**DOCKET**  
**09-AFC-9**

RE: Ridgecrest Solar Power Project (RSPP), Docket No. 09-AFC-9, Ridgecrest Solar Power Project  
Potential Mission Impacts – Response to Naval Air Warfare Center, date May 25, 2010

RE: Ridgecrest Solar Power Project Potential Mission Impacts – Response to Naval Air Warfare Center, date May 25, 2010

# Glint/Glitter Evaluation of SEGS, and Convective Plume Evaluation of Walter Higgins Power Plant

**Figure 1**  
**Region of Significant Thermal Deviation**

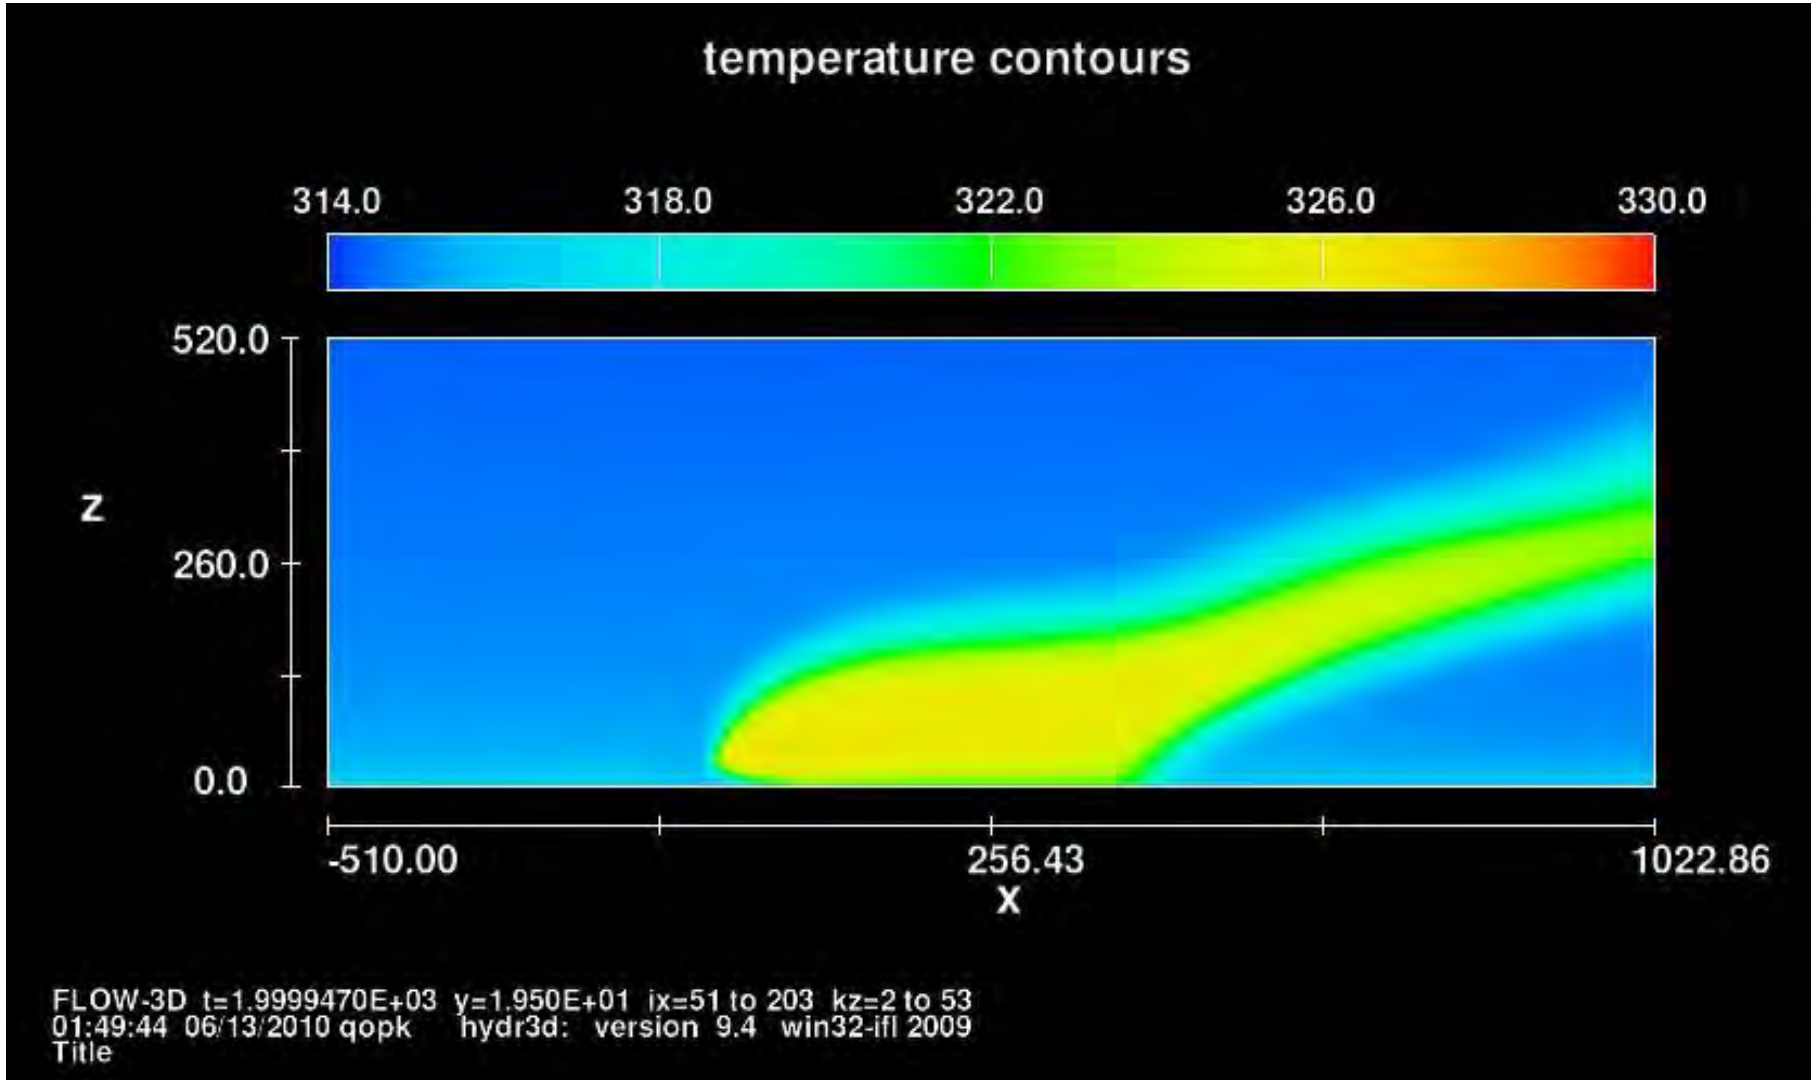
In the case where one is sighting from the ground, into the sky the observation point would need to close since the region of significant thermal deviation is rather shallow as shown in Figure 1. Otherwise the observation angle would need to be extremely shallow.

**Figure DR-S&W-133-2  
 Predicted Water  
 Difference 2013  
 and 2043 Scenario(3a)  
 and Project (4a)**

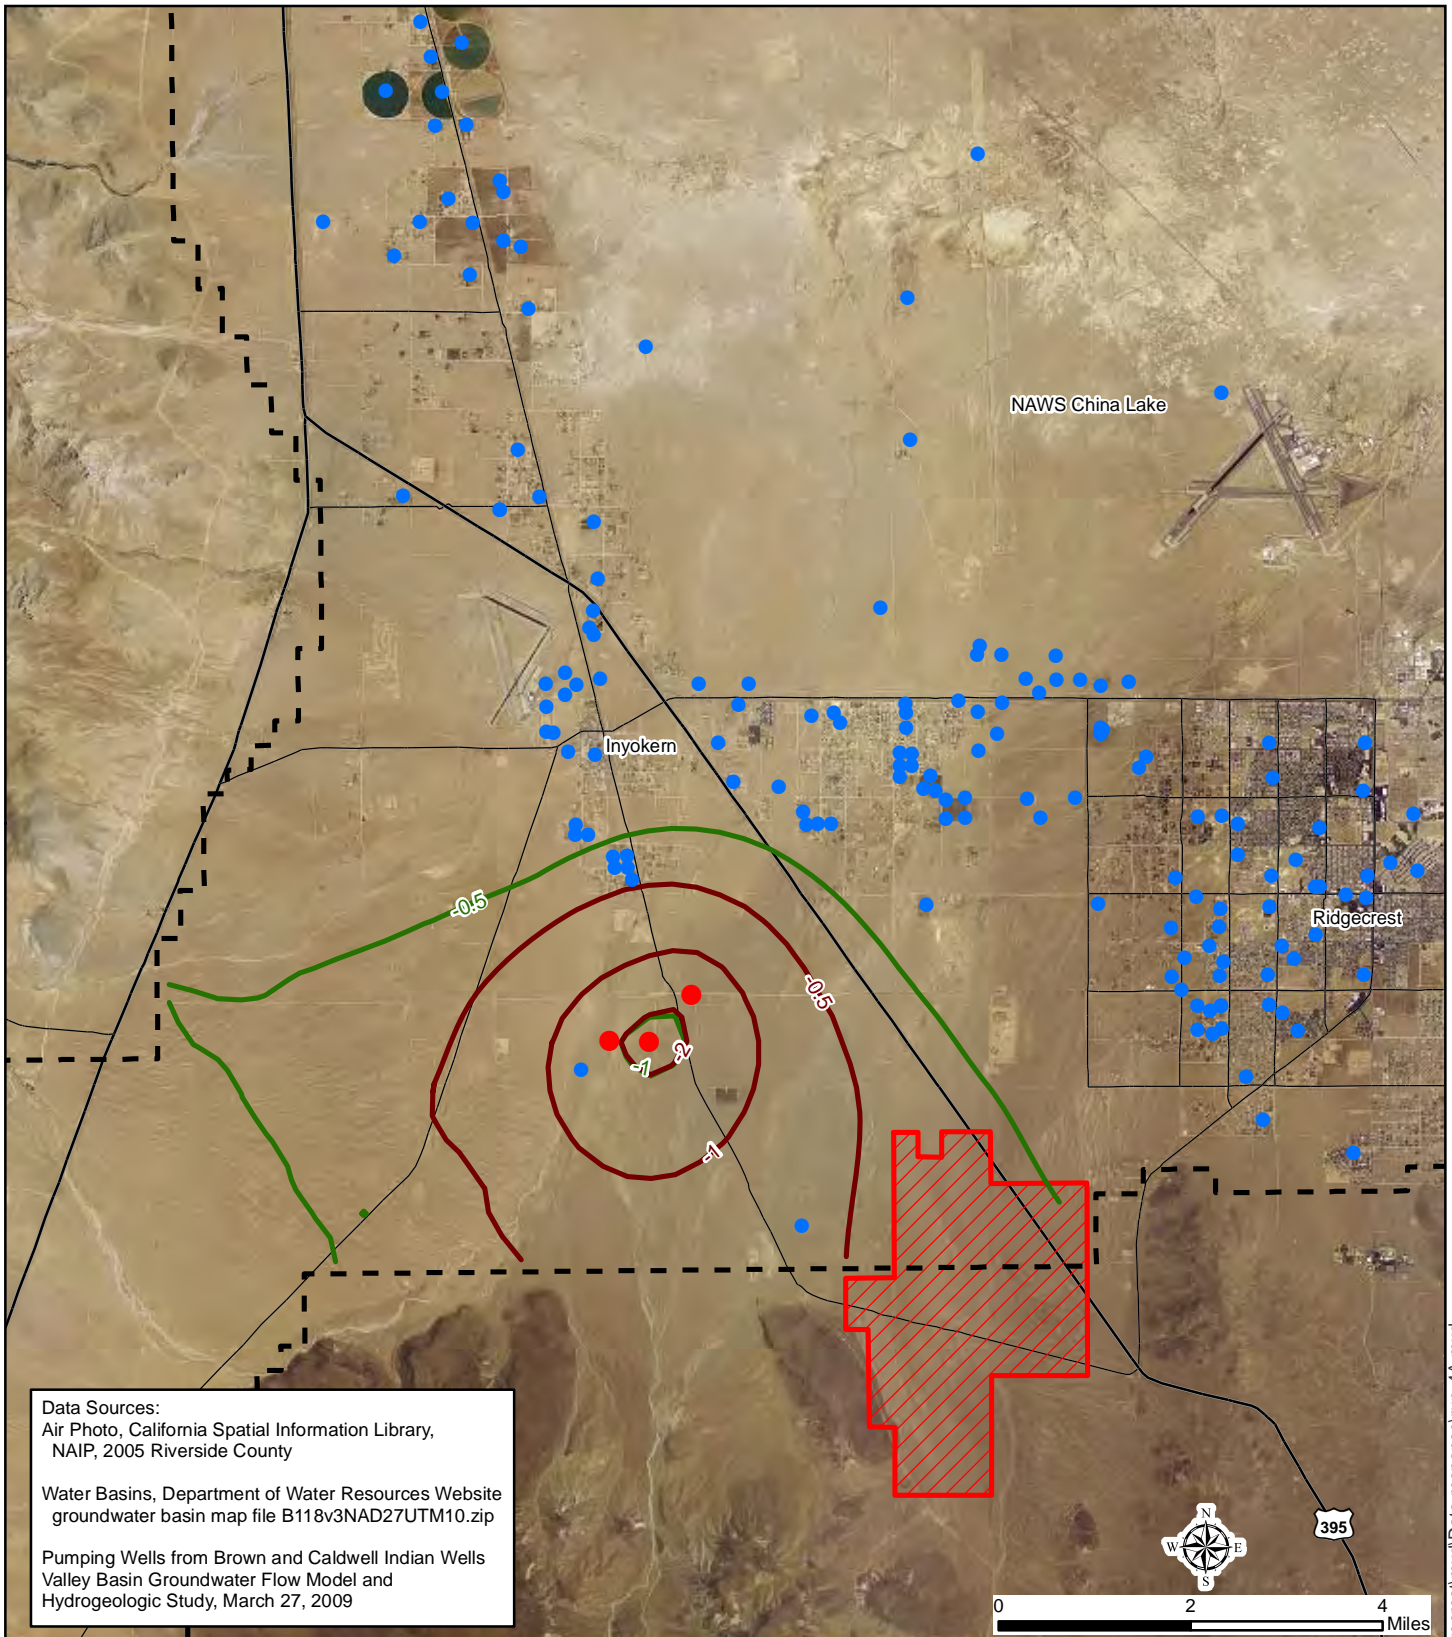
As part of our application and subsequent Water Mitigation Offset Plan, RSPP modeled the potential impact of our water use with the same model used by the local aquifer users to manage water resources. Enclosure 2 the data response dated January 25, 2010 to the CEC which modeled potential impacts to wells in the region from RSPP's water use. The modeling (see response #133) revealed that NO adjacent water supply well to the proposed project pumping wells (IWVWD 18, 33, and 34) would "see" a drawdown of 5 feet or more at the end of the model period of 30 years. Five feet of drawdown is the standard that has been used in licensing projects to indicate a measure of significance of impacts to adjacent wells from pumping. Of the wells shown on the maps that would "see" any drawdown (0.5 foot or greater) (see figures 133-1 through 133-3), none of these wells appear to belong to

Figures DR-S&W-133-2 and DR-S&W-133-3 show the difference in drawdown from Project induced pumping by comparison to the no project Scenario 3a/3b which includes the draught year conditions and increases in projected regional pumping through the District. The figures show the difference in the predicted drawdown for the end of construction (2013) and for the end of the project (model year 2043). As shown for Scenario 4a (25% of the baseline recharge) the Project-induced pumping adds less than 5 feet of drawdown in the area of the pumping wells, and between 0.5 and 1 foot of drawdown to the most proximal adjacent water supply wells (Figure DR-S&W-133-2). As shown for Scenario 4b (15% of the baseline recharge) the results are the same, revealing that the model is not sensitive to variations in the draught scenarios and the change in recharge at the frequency applied in the model (Figure DR-S&W-133-3).
